## Certificate of Appropriateness

2479 N. Sherman Blvd. Sherman Boulevard HD (Greater Mount Zion Missionary Baptist

Church, FKA Immanuel Reformed Church)

PTS ID 114878 COA roof repairs

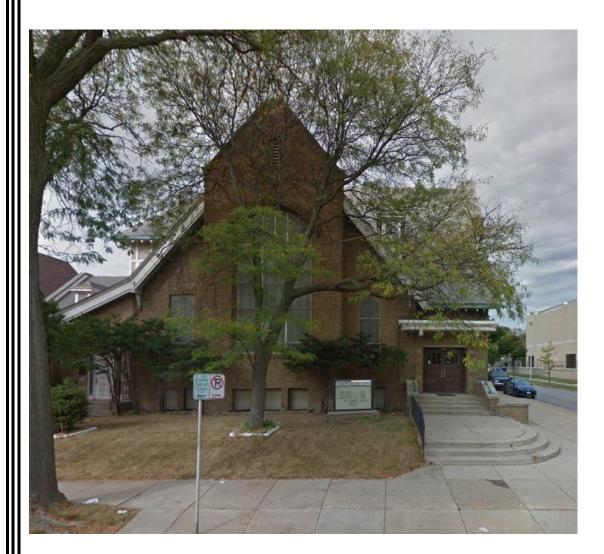
> Alterations to the standing seam roof at the southwest of the original building are approved as a temporary repair. Any future roofing project that addresses the majority of the building will have to incorporate this area into the comprehensive roof design with materials that match the new primary roofing material or restore the standing seam roof in this location.

No dormers, chimneys, moldings parapets, or other permanent features will be altered or removed. Valleys and flashing must be painted or factory-finished to match the roofing color, unless copper. When installing new flashing at a masonry feature, the flashing must be stepped or cut into the mortar joints. The bricks may not be cut to install flashing at an angle.

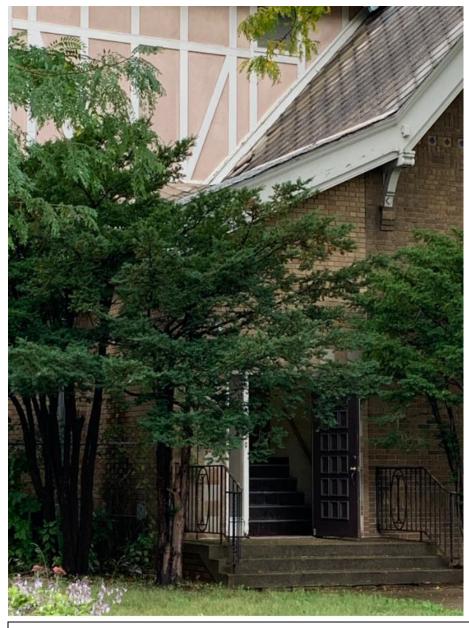
Area of concern above the front doors at the east side of the building. Asbestos shingles appear to be missing and water is actively leaking into the entrance. Up to 10 shingles will be removed, an Ice & Water Shield underlayment will be installed, removed shingles will be reinstalled and missing shingles will be replaced with asbestos shingles that match the existing size, color, and thickness.
